# JOURNAL OF COASTAL AND HYDRAULIC STRUCTURES

Review and rebuttal of the paper

## Investigating Wave Transmission through Curtain Wall Breakwaters under Variable Conditions

## RESPONSE LETTER TO EDITOR AND REVIEWERS

Fig. S1. Arrangement of the wave flume in the numerical model (for long wave-periods of 4s to 8s).

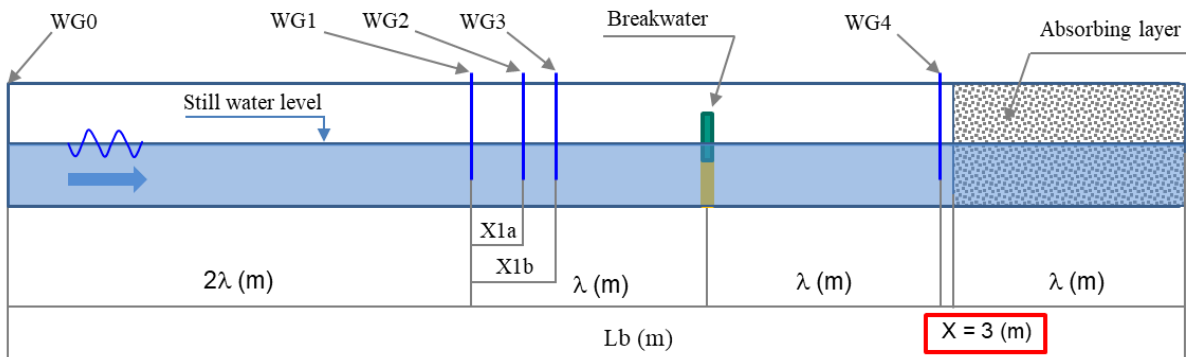
**Comment 11:** In Figure 5, the author to explain how the readings from WG4 will not be affected by this close distance from the absorbing layer. Moreover, to include the distance between WG4 and the absorbing layer.

Thank you very much for your notification. The distance  $X$  from WG4 to the absorbing layer was setup of a wave length  $\lambda$  (m) for short-wave periods of 2 s to 3.5s, while  $X = 3$  m for longwave periods of 4s to 8s to save the computational time and data storage. We corrected the sketch of wave flume setup by adding  $X$  (m), see lines 256 – 259, page 7.

Here, we made a sensitivity analysis to examine if  $X = 3$  m is affected by the absorbing layer in case of long-wave periods (Fig. S1). Specifically,  $X$  varied from 3 m to 20.8 m (one wave length) and 30 m for the water depth of 4 m, wave height of 0.6 m, wave period of 4 seconds. The CWB I\_120  $\square$  was tested in the flume, bottom gap of 1 m and no overtopping. It can be seen in Fig. S2 that, when  $X$  changed from 3 m to 30 m, the wave transmission coefficient remained at a similar value of 0.23. It means that as the wave absorbing layer works effectively to absorb all incoming waves, the distance  $X$  between the WG4 and the absorbing layer can be reduced in the numerical approach to save the computational time and data storage.

Fig. S3. Layout of a capacitive wave sensor.

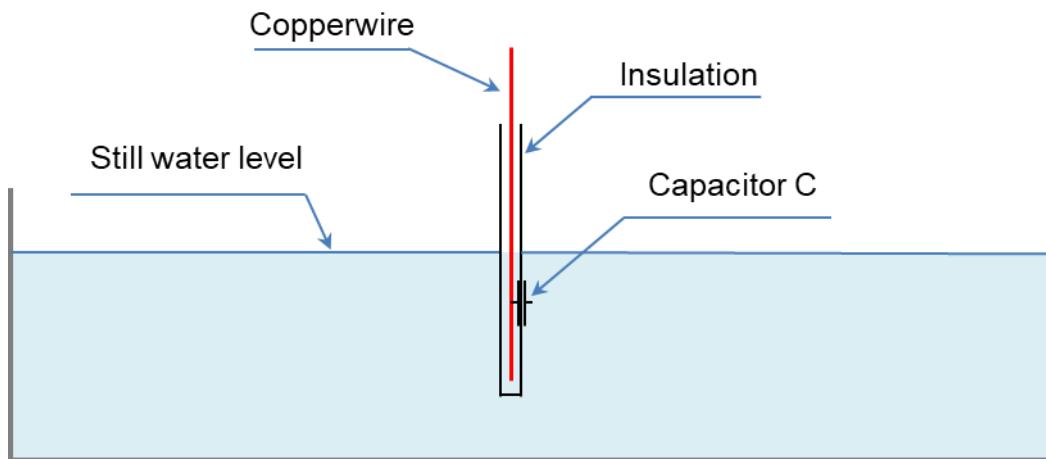
**Comment 15:** The author to give more information for the equipment and software that were used for taken the measurement of the wave parameters, and how they are working, how they are taking measurements and equations they solve in order to provide the wave parameters.

The capacitive wave sensors were manufactured at the KIT-IWG, they include a copperwire, an insulation, and a capacitor C (Fig. S3). When water level goes up and down, the capacitor C changes his value, i.e., low- and high-values of C corresponding to the low- and high-water levels, respectively.

The Capacitor is a part of a sine wave generator (G).

If C is low (low water level) the frequency is high, if C is high (high water level) the frequency is low. In our case the probes are setup with low water level of 10 kHz, high water level of 2 kHz.

Next step is a frequency to voltage converter and linearisation (Lin).

The Linearisation is necessary, because in wave generator  $f$  is a function of  $1/C$ . This linearized voltage is given to an AD-Converter to read it and save data into a computer through the LabView (National Instruments) program. The wave data was acquired at 20 Hz.

Fig S4. Sensitivity analysis of water viscosity, density and temperatures in wave transmission coefficient through A2S- configuration.

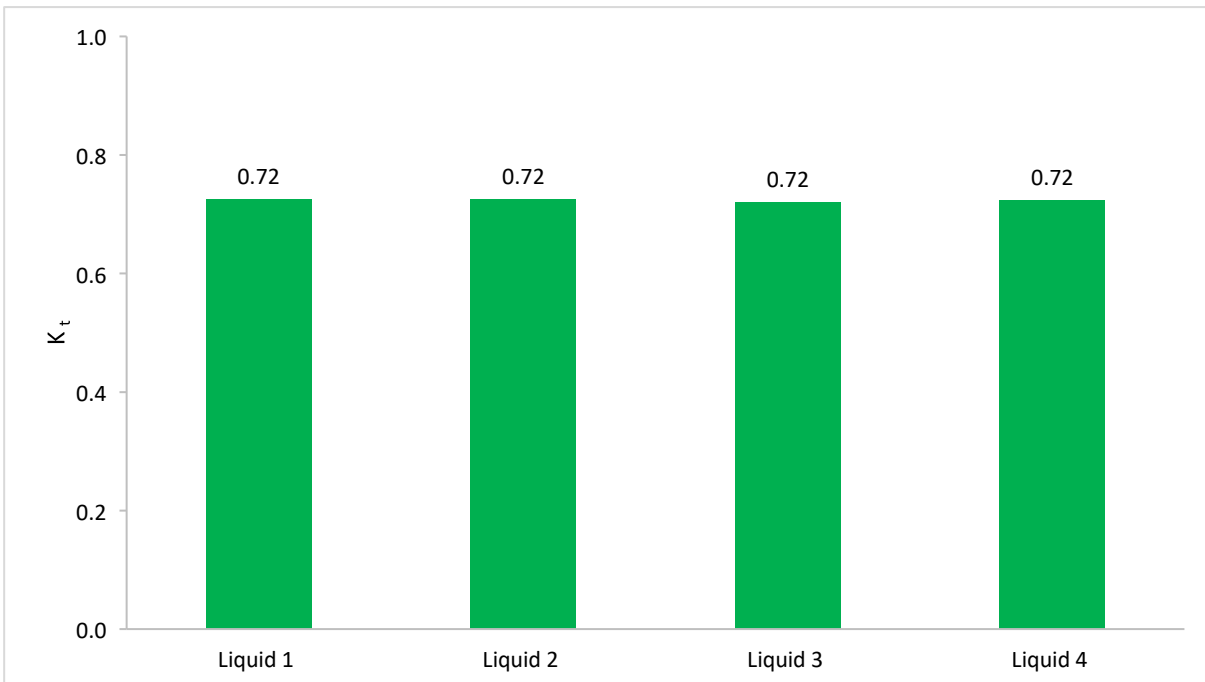
**Comment 18:** The author to include the sensitivity analysis of all the parameters and locations.

The sensitivity analysis of water temperature, water viscosity, and density of water were analysed in numerical modeling to test the  $K_t$  through the structure A2S- (bottom gap of 2m, no supporting piers, non-overtopping). Linear wave parameters included water depth of 4m, wave height of 0.6m and wave period of 4s. Four liquids were examined, i.e., fresh water at 20 °C, salt water with the temperature varying from 14 °C to 30 °C. The characteristics of four liquids have been provided in Table S1. It can be seen in Fig. S4 that, no differences in  $K_t$  values are detected under four different liquids, the  $K_t$  has similar value of 0.72. Therefore, our investigations using fresh water at 20 °C are seen to be reliable.

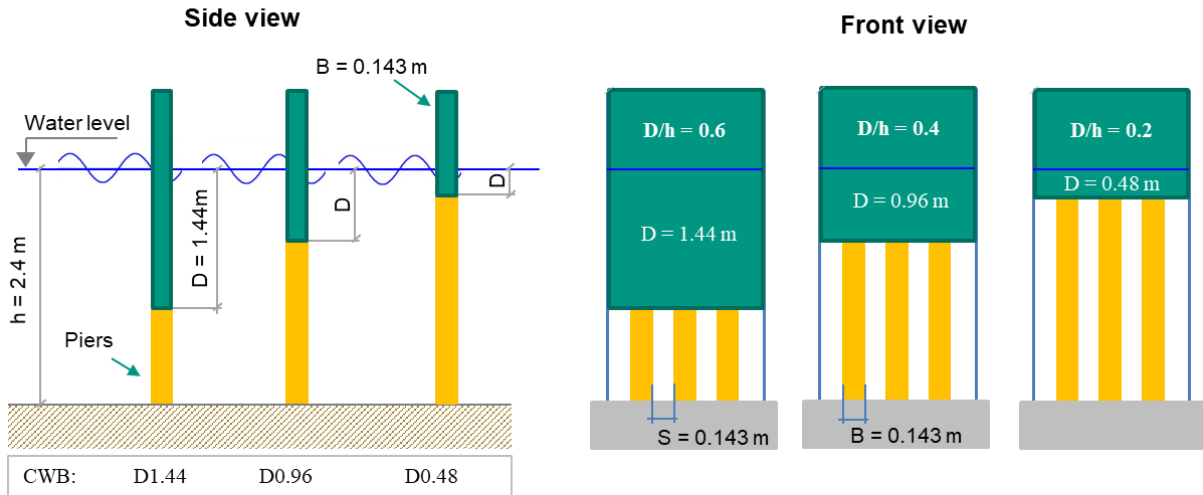
**Comment 19:** The number of points based on the experiment (four in total) are not sufficient to make comparisons and calibrations with the numerical model (especially only for regular wave conditions). The author to explain and defend the author’s decision for the approach that was taken.

Thank you very much for your comment, our explanation was misleading. Actually, there were in total eight (8) tests (four kinds of structures in two different wave periods and heights) in the small-scale experiments at the KIT-IWG. The approach of our study is to use physical results to prove the reliability of the numerical approach, then apply the numerical approach for further investigations of multiple CWBs under the Mekong wave characteristics in the full-scale.

Fig. S6: Grid convergence for wave transmission through the structure I\_120°.

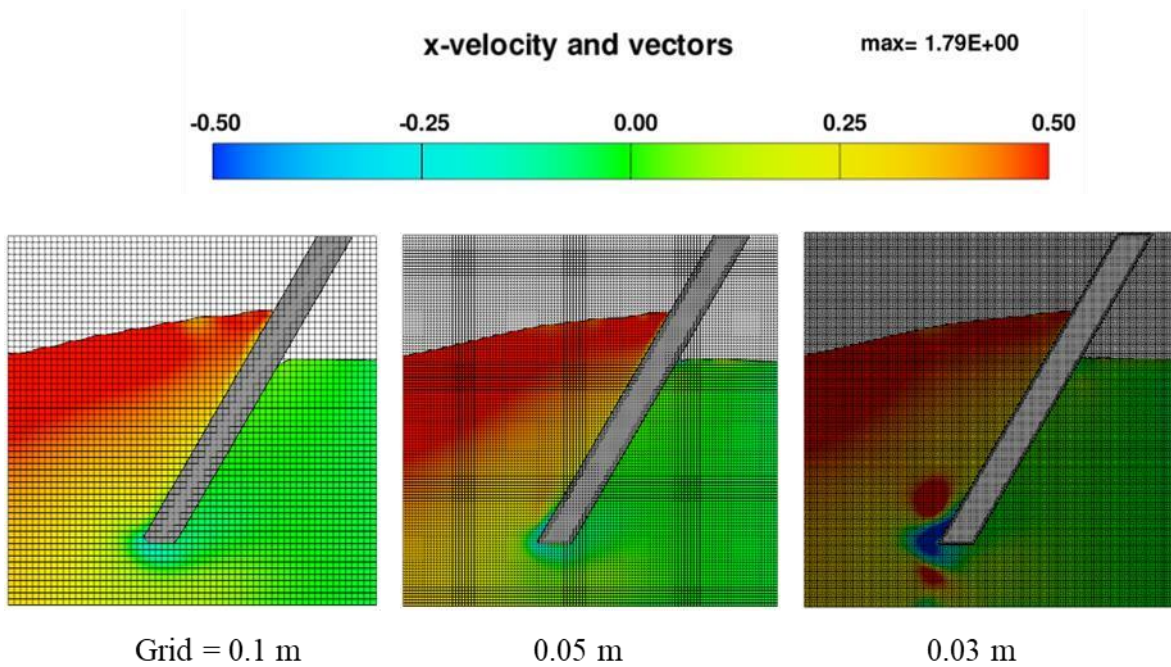
**Comment 3:** Some numerical set up details should be much better clarified, e.g. if a convergence test was carried out, the Courant number. Also, some more details on the wave generation mechanism should be provided.

A convergence test based on grid-size sensitivity analysis was mentioned in the manuscript, see lines 336 - 349, pages 11 - 12.

On the other hand, numerical uncertainty is additionally assessed in terms of the fine Grid Convergence Index (GCI) introduced by Celik et al. (2008) using three different representative cell sizes to examine the  $K_t$  values through the structure I\_120°. Here, three grid-sizes of 0.03m, 0.05m, and 0.1 m are selected corresponding to the  $K_t$  values of 0.235, 0.233, and 0.227 (Fig. S6). As  $K_t$  is an important coefficient to evaluate the wave energy breaking of breakwaters, hence, small changes could result in large numerical uncertainty identified in terms of the GCI. For this case, GCI remained low of 1.2%, therefore, this does not account for modeling errors.

Fig. S7: Correlation of  $K_t$  values between numerical simulations (CFD) with small-scale (a) and full-scale (b) experimental results (EXP).

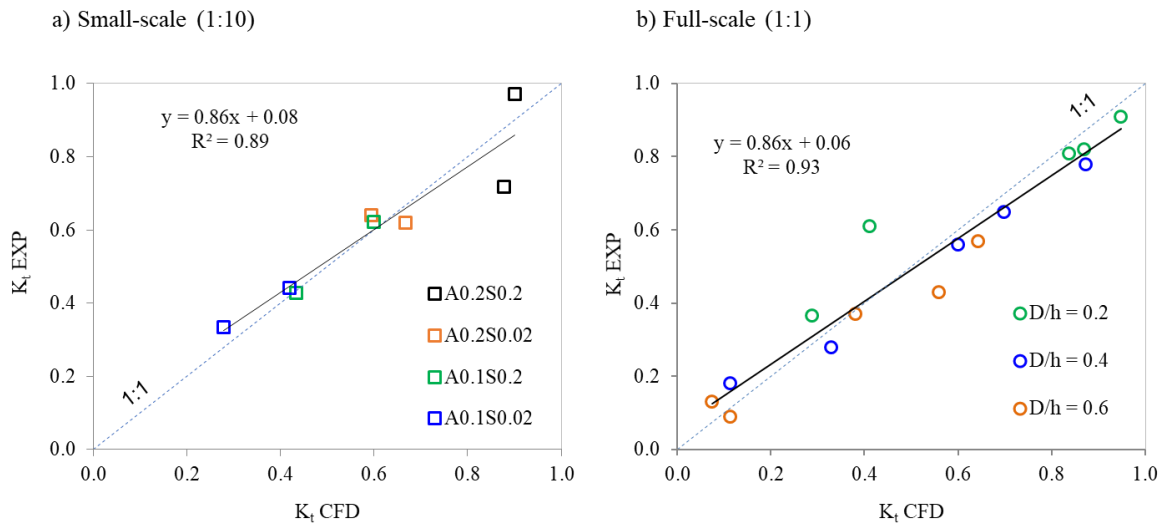
**Comment 10:** Line 28-30 "high agreement" is not quantitative, high respect to which metrics should be defined. Use normalised RMSE or similar for, e.g. flow variables.

Thank you. We adapted your comment in comparison of wave transmission coefficients between numerical and physical models in small-scales and large-scales with the correlations  $R^2 = 0.89$  to  $0.93$ , respectively. See Fig. S7 below.

We clarified it in the revision, see lines 24 – 25 in the abstract, and lines 361 -366 at pages 13 - 14.
